160 Avenue NW Functional Planning Study

What We Heard Report – July 2026

Proposed Bridge over West Nose Creek

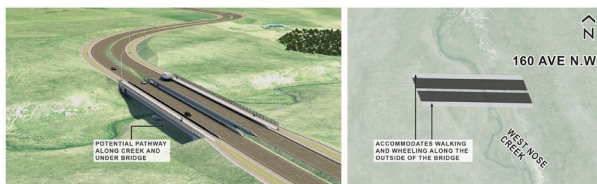
- **Active Transportation Infrastructure** - One participant expressed support for the inclusion of a dedicated pedestrian and cycling pathway within the project.
- **Balancing Capacity and Environmental Considerations** - One participant supported a four-lane roadway configuration and emphasized the importance of minimizing impacts to the adjacent creek.

- I like the inclusion of a pedestrian/cycle path
- 4 Lanes, minimized impact on creek,
